RESPONSES TO NRC REQUESTS
DATED APRIL 22, 1977, FOR ADDITIONAL
INFORMATION REGARDING THE PROPOSED COOLING
SYSTEM DESIGN CHANGE

DOCKET NO. 50-410

NINE MILE POINT NUCLEAR STATION - UNIT 2
NIAGARA MOHAWK POWER CORPORATION

SEPTEMBER 30, 1977

FIGURE RII-1
 LOCATION OF INTAKE AND
 DISCHARGE STRUCTURES
 NINE MILE POINT NUCLEAR STATION - UNIT 2
 NIAGARA MOHAWK POWER CORPORATION

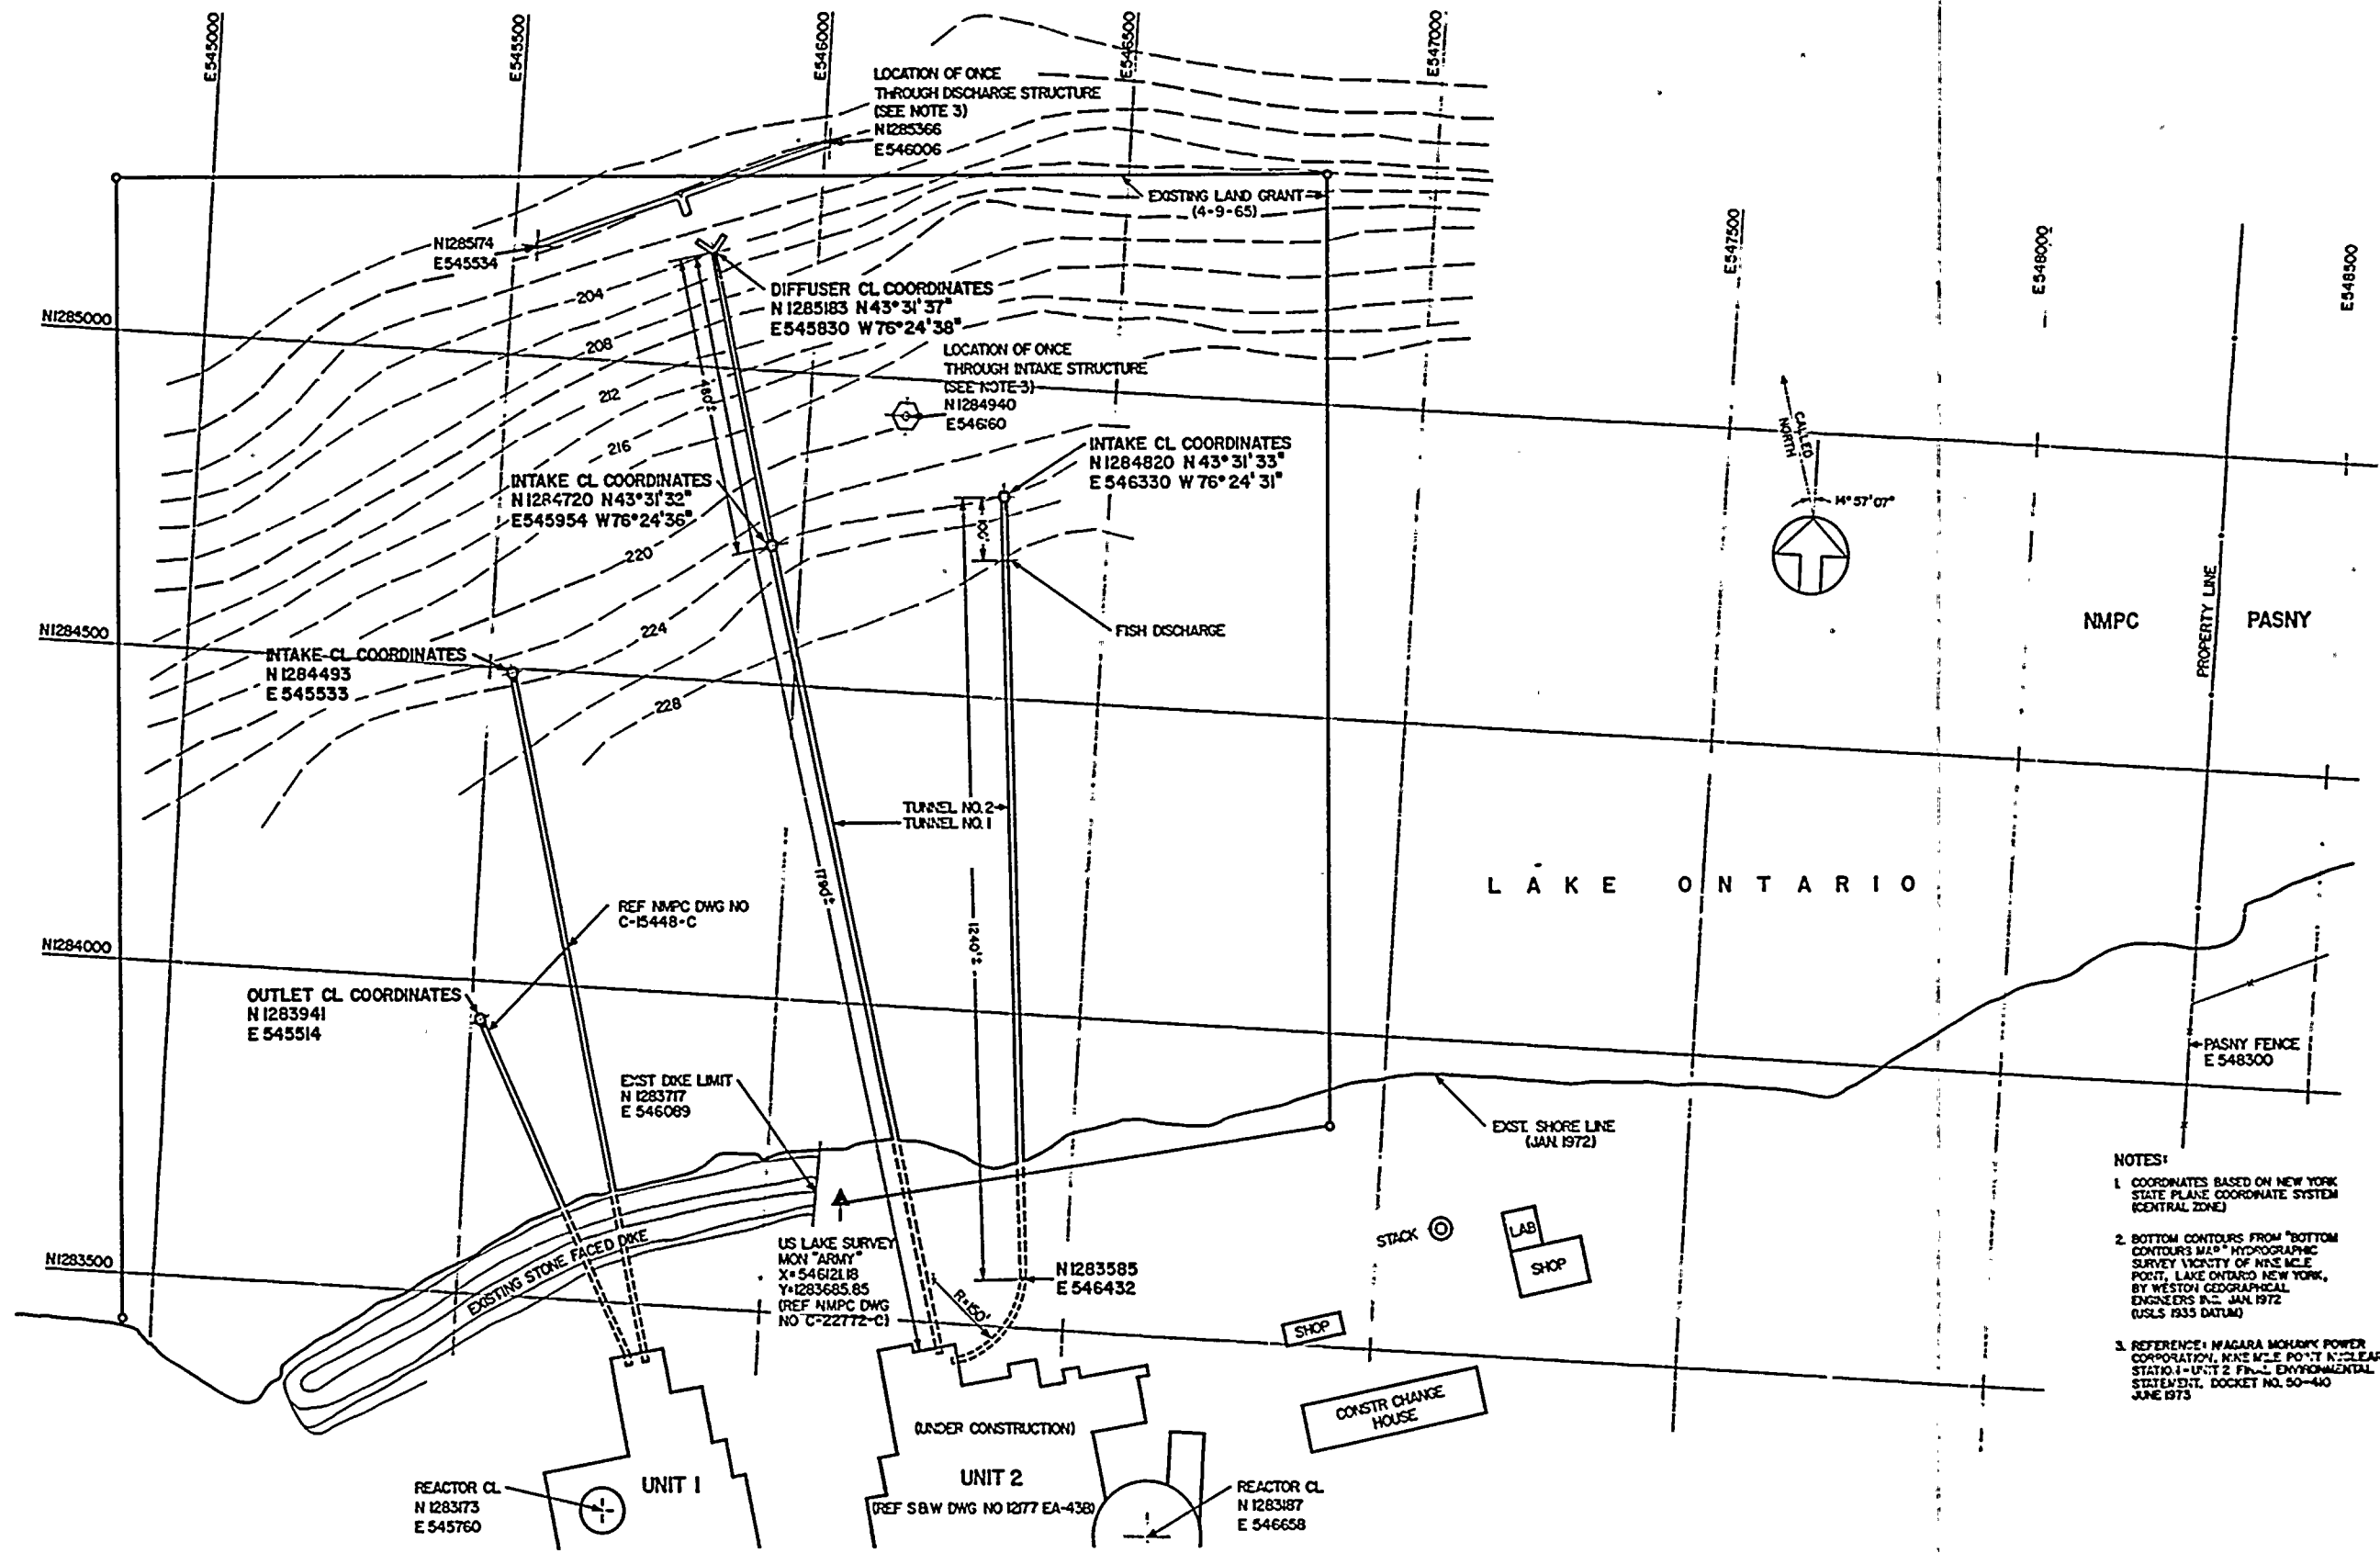
Clarify if the proposed design change will result in placing the intake and discharge structures at different locations from those previously reviewed. If applicable, any new location should be described with respect to:

- a) the location of the previously proposed once-through system intake and discharge structures;
- b) the locations of the sampling stations occupied to assess impacts;
- c) the abundance of aquatic biota and species considered "important" with regard to potential impacts of construction and operation;
- d) the potential effects of construction and operation of the intake and discharge structures in their new proposed location.

- a. The revised locations of the cooling tower intake and discharge structures for Unit 2 are shown on Figure R11-1 along with the previously submitted locations for the once-through cooling system. (A complete description of the intake discharge system and the range of operating conditions are given in the Response to Request 12.) As can be seen from Figure R11-1, the east intake is located approximately 200 ft to the southeast of the previously submitted Unit 2 intake location and will be located in approximately 19.5 ft of water as compared to 26.5 ft for the previous design (all depths relative to mean low water lake level, El. 244 ft USLS 1935 Datum). The currently proposed discharge structure is located approximately 100 ft southeast of the center of the previously proposed diffuser at a water depth of approximately 37.5 ft from the centerline of the diffuser nozzle to the surface at minimum controlled lake elevation (lake El. 243 ft USLS 1935 Datum). The proposed west intake structure is located approximately 480 ft shoreward of the new discharge along the same depth contour as the east intake.

- b&c. The revised locations of the intake and discharge structures along with the location of the second intake structure are so close to the previous locations that the biology of the area would be similar. Thus, the previously submitted information on abundance of aquatic biota and "important" species is completely applicable to the new locations. Also, the same sampling stations would be used to evaluate potential impact.
